TILE ROOF WORKSHEET

re: Job 98309: RICHARDSON

Subject: Structural Investigation Report of the Roof for the Residence located at 6700 Breakwater Way, Sacramento, CA 95831.

1 ROOF PLAN - RICHARDSON
N.T.S.

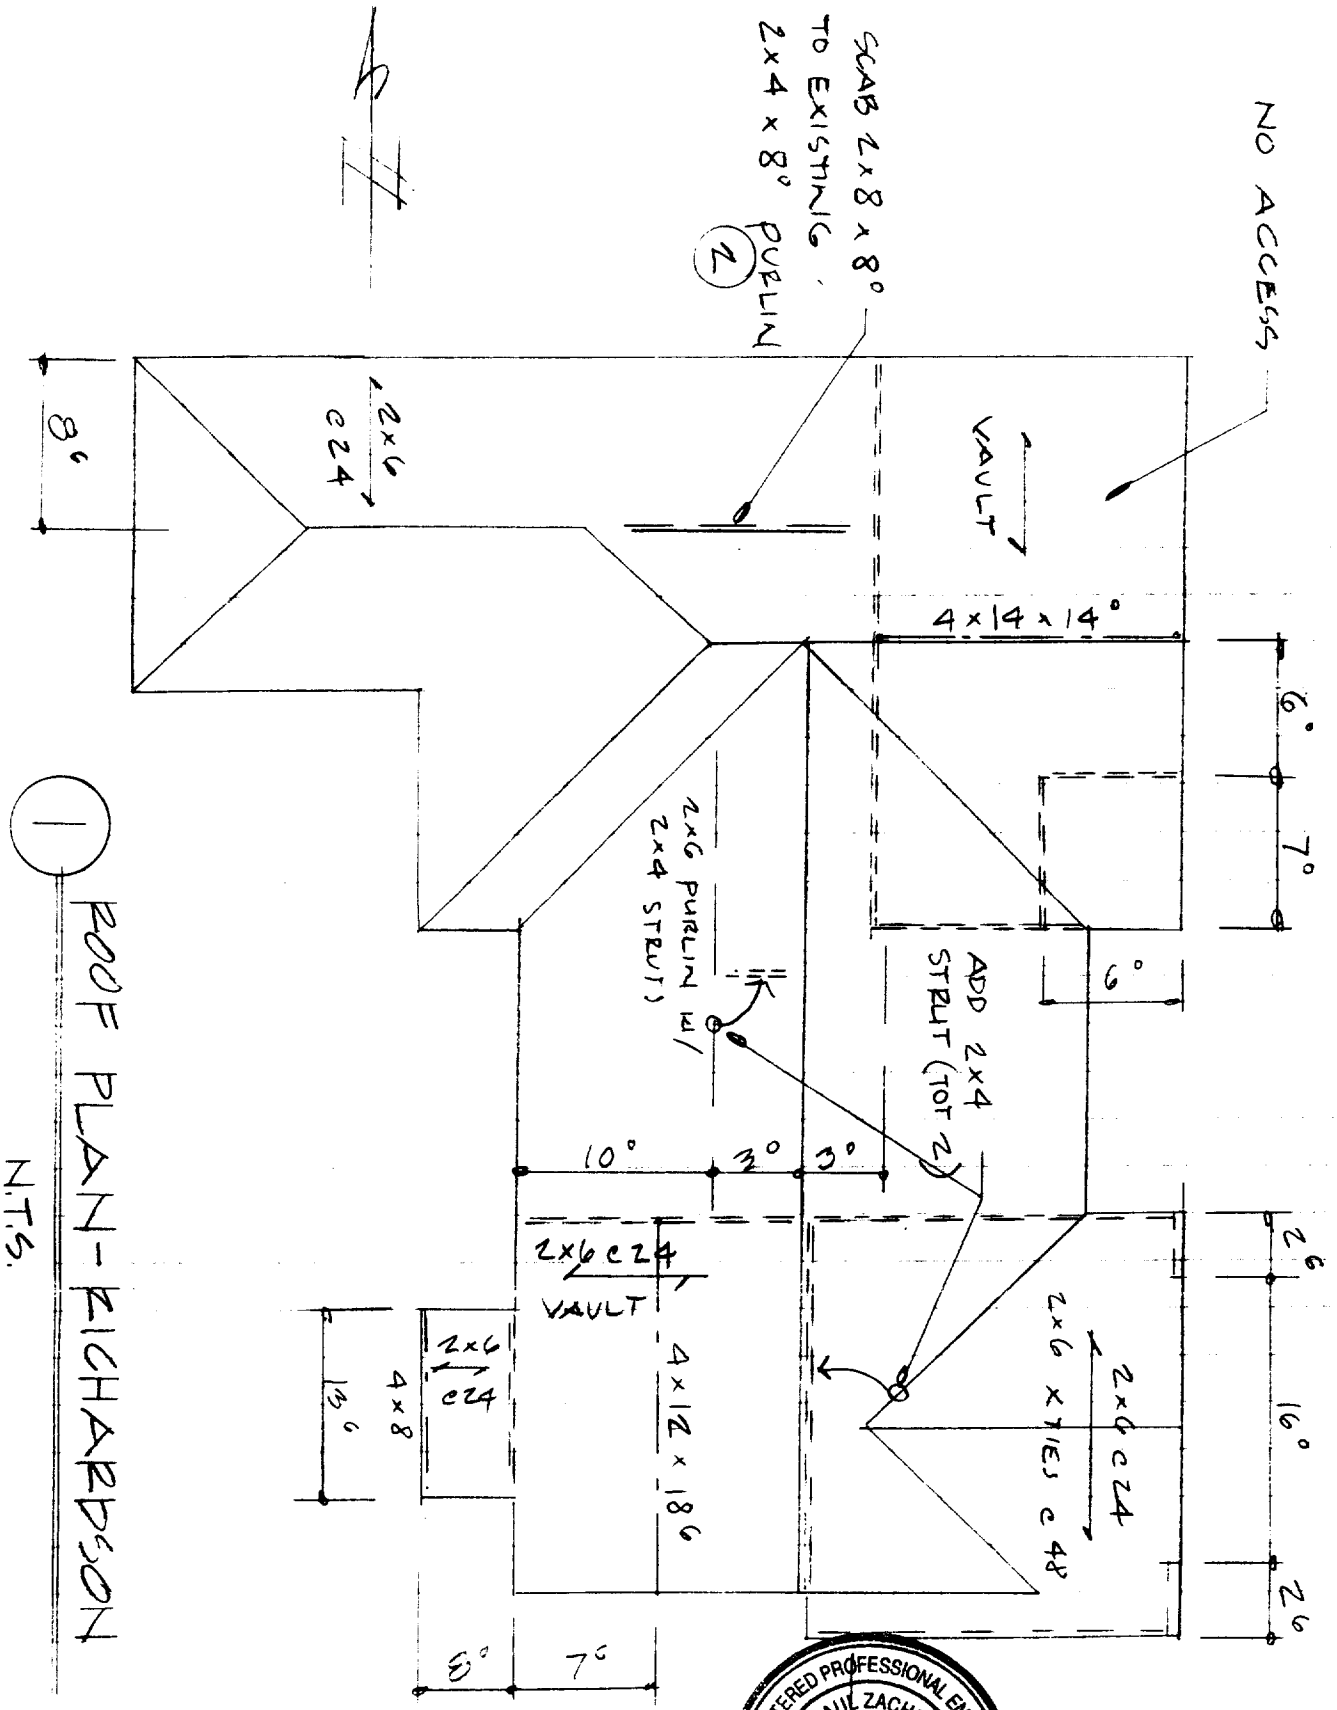
The living and garage areas lack sufficient structural capacity for the applied live and dead loads.

4. Provide a 2x4 strut from the existing valley to the bearing wall below. The minimum slope of the strut shall not be less than 45 degrees from the horizontal. See detail 1.

PURLIN DETAIL

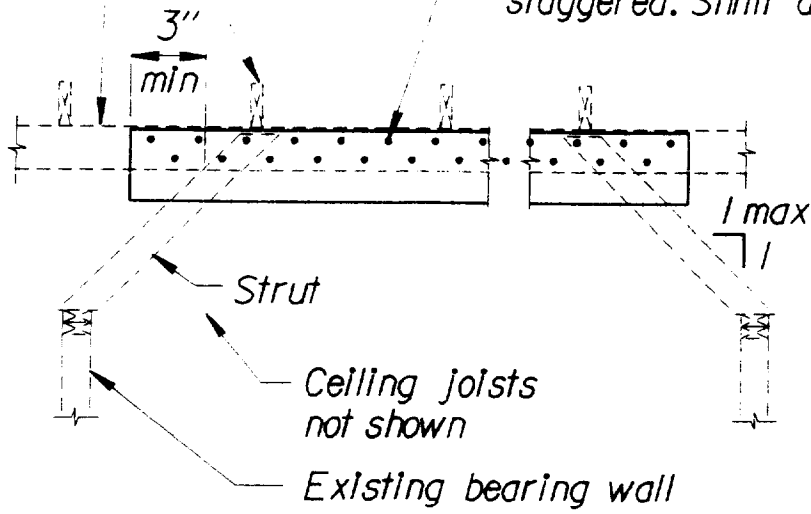
— Purlin. Nail to existing purlin w/ 16d @ 3" oc, staggered. Shim as required.
